Access Compliance Report

Public Rights-of-Way

| Intersection ID: N/A | Main Street: ALLEGIANCE DR | Cross Street: LADY LIBERTY LN | Location: NE |
| ADA ID: 9D111B141C00 | Ramp Type: BlendTrans1 | Initial Pass/Fail: Fail | Overall Compliance: No |

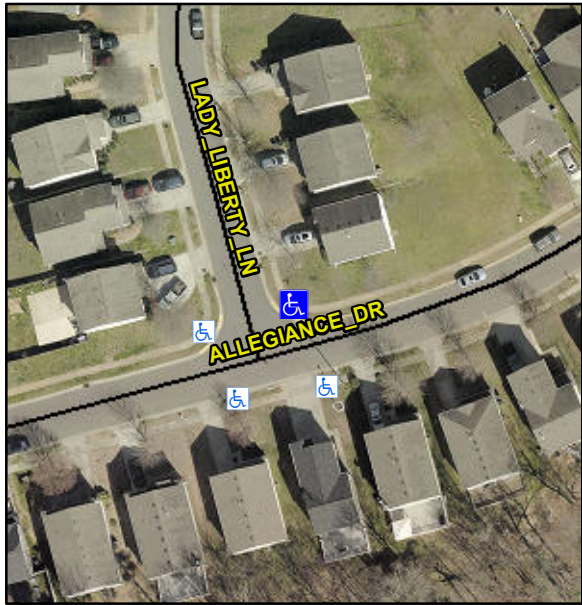
| Codes/Mitigation Info/Possible Solution | | | Field Measurements/Component Compliance | | | | | |
|--|---|-----|---|-----------------------|------|-----------------------------|-----------------------|------|
| | Remove & Replace Curb Ramp With Two New Directional Ramps or Equivalent. | | N/A | Ramp Length (in) | 49.0 | Yes | BlendTrans Slope (%) | 4.7 |
| | | | No | Ramp Width (in) | 43.0 | No | BlendTrans XSlope (%) | 8.4 |
| R304.5.1, R304.5.3 | | N/A | Gutter Ponding? | N/A | N/A | Gutter Slope (%) | N/A | |
